**SUBJECT Extension Request for Site Assessment Report and Relocation of
Proposed Monitoring Wells**

Former ExxonMobil Jalk Fee Property
10607 Norwalk Boulevard
Santa Fe Springs, California
CRWQCB-LAR Case No. 0203; Site I.D. No. 1848000

Plate 1 Generalized Site Plan

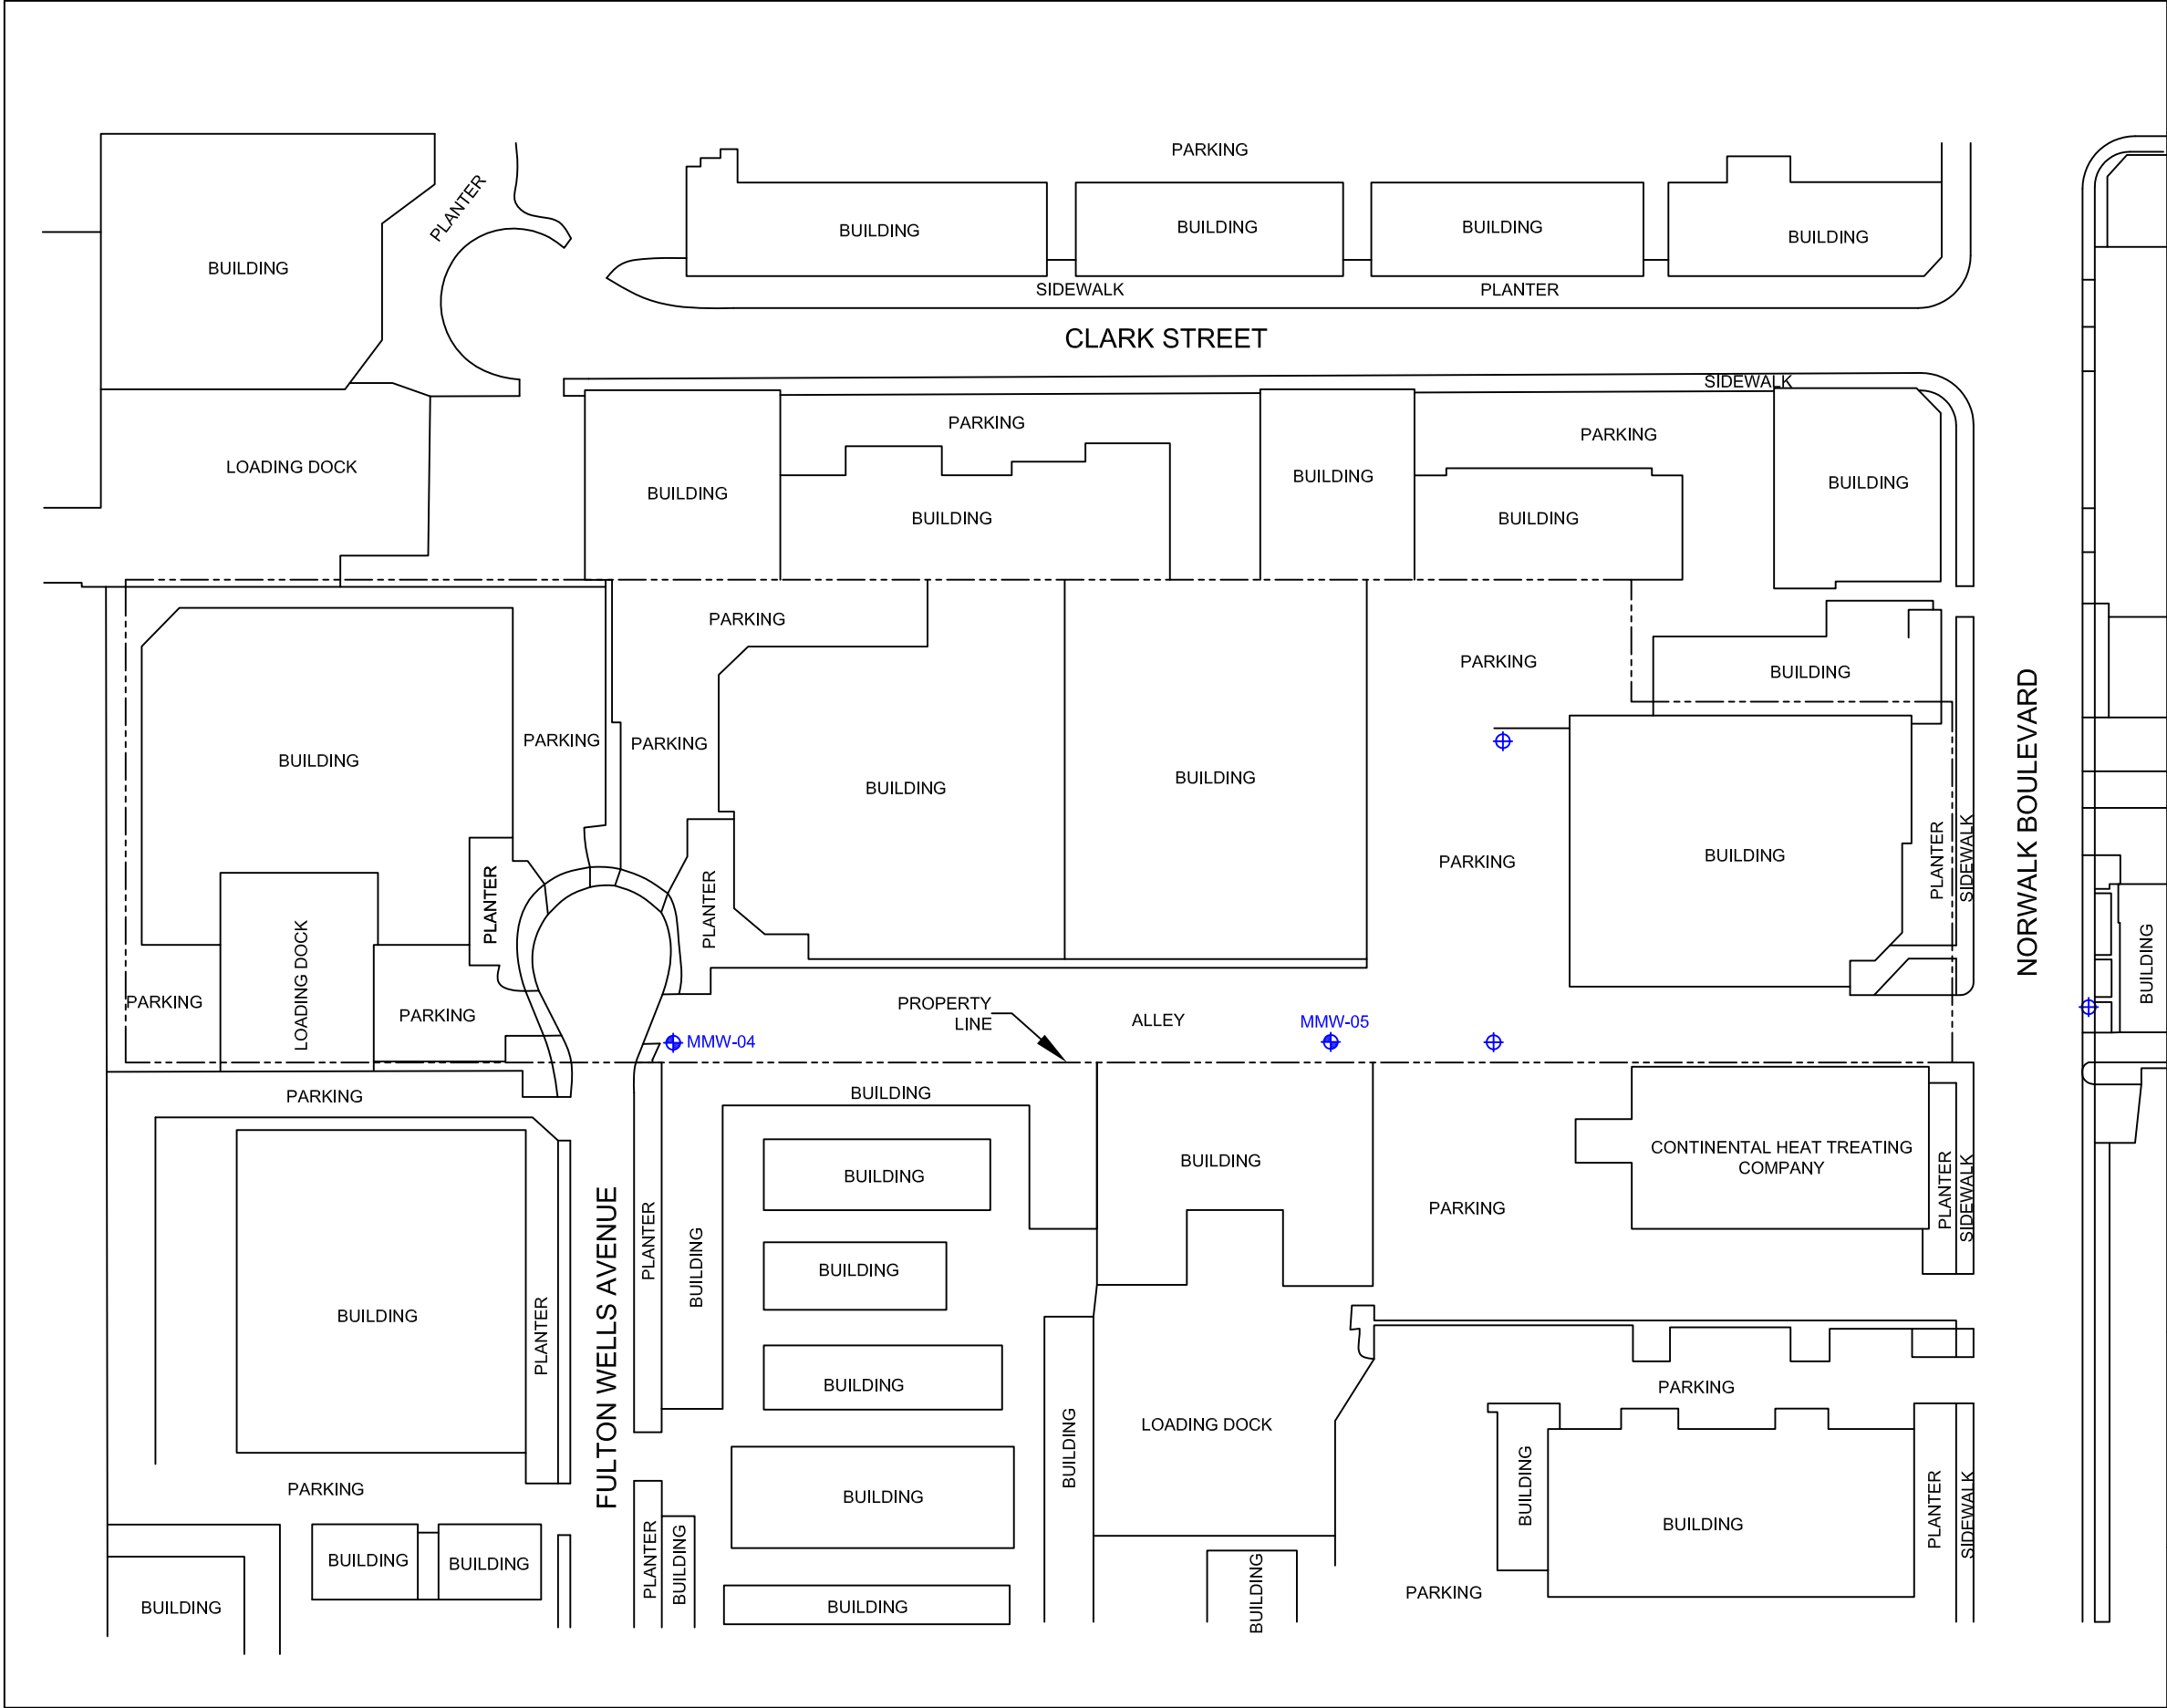
Cardno ERI's Work Plan proposed the installation of one off-site and two on-site groundwater monitoring wells. The off-site well was to be installed in Norwalk Boulevard, however, during the permitting process, the City of Santa Fe Springs (City) stated it has a new policy which does not allow installation of wells in any City street. Therefore, the proposed well is being relocated to the sidewalk along the east side of Norwalk Boulevard (Plate 1). Additionally, the City has required significant non-standard insurance requirements as part of the encroachment permitting process, which Cardno ERI's insurance company and the City have been negotiating. It is anticipated that the encroachment permit will be issued during the week of February 21st, 2011.

The proposed upgradient monitoring well location is in front of the door of the warehouse for Coast Aluminum, which is heavily trafficked by trucks, therefore it is proposed to move the well to the location depicted on Plate 1, to minimize interference with the operations of the on-site businesses.
